Ref: 29011.00

Re: MDP and Site Plan Phase 1 Comments
Silo Ridge Resort Community
Amenia, NY

On behalf of our client, Silo Ridge Ventures, LLC., "the Applicant", VHB Engineering, Surveying and Landscape Architecture, P.C. (VHB) offers the following responses to your comments dated October 17, 2014 (numbered in accordance with your letter).

Construction
 Drawing Title
**Sight Distance
Triangles 2**

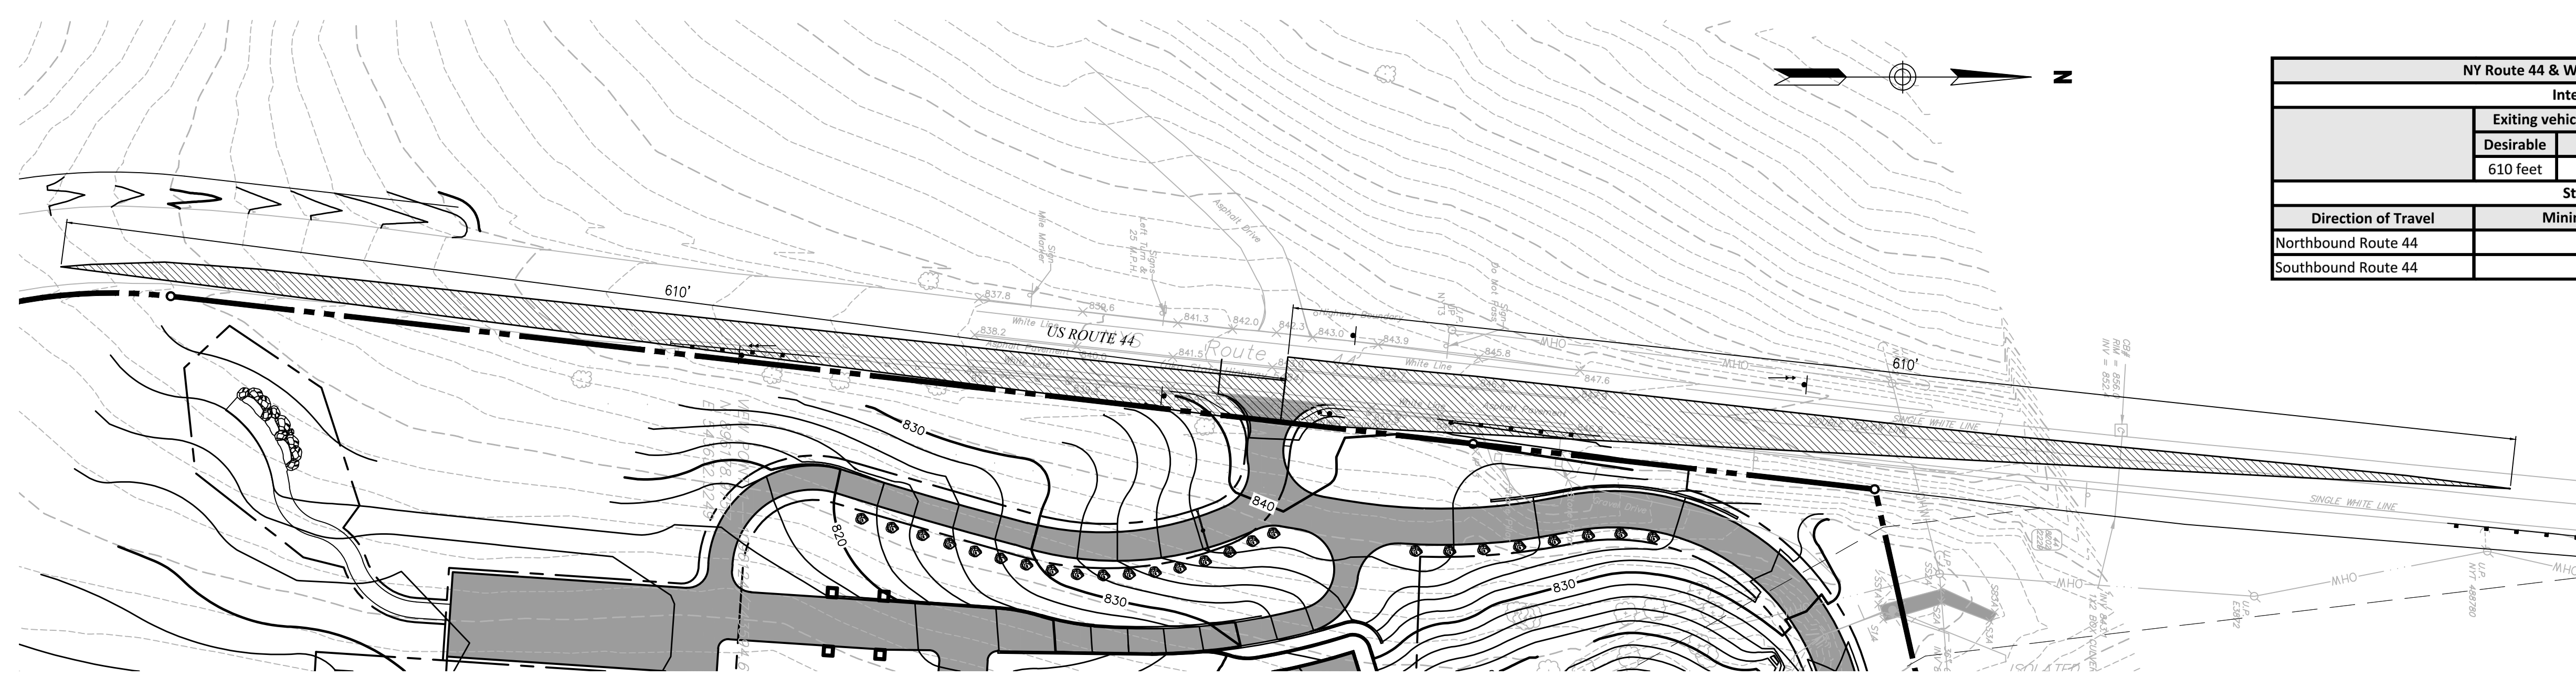
5. Comment: Show sight distance triangles on the plans for all turning movements at all entrances. Provide a matrix at each location detailing required sight distance for each type of movement and available sight distance.

Response: Sight distance triangles and matrices indicating available and required sight distances at each location have been included on Drawings SD-1 and SD-2, dated January 8, 2015.
